# Access Compliance Report

## Public Rights-of-Way

| Intersection ID: 53397                  | Main Street: AGNEW_DR | Cross Street: PAMPLIN_CT | Location: SW                            |
| ADA ID: 6F8BFC8F233B                    | Ramp Type: Perp       | Initial Pass/Fail: Fail  | Overall Compliance: No                  |

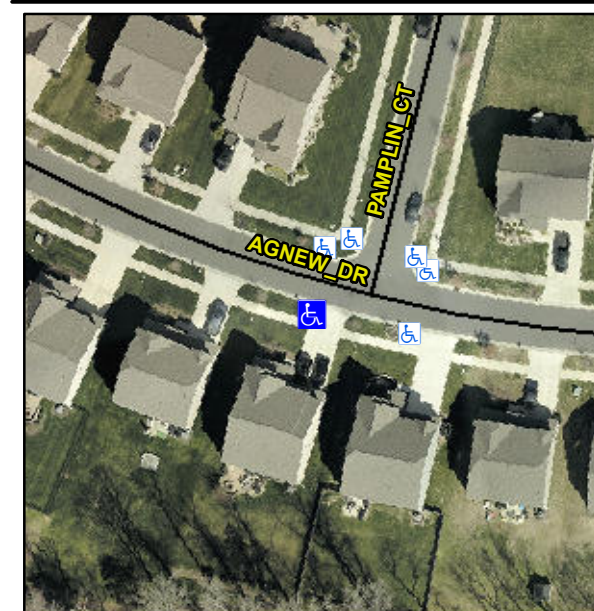
**Not Found, R304.5.1, R304.5.3**

| Compliance | Description           | Data  | Compliance | Description                 | Data |
|------------|-----------------------|-------|------------|-----------------------------|------|
| N/A        | Ramp Length (in)      | 96.0  | Yes        | Ramp Slope (%)              | 6.3  |
| No         | Ramp Width (in)       | 47.0  | No         | Ramp XSlope (%)             | 3.0  |

**Remove & Replace Entire Ramp.**
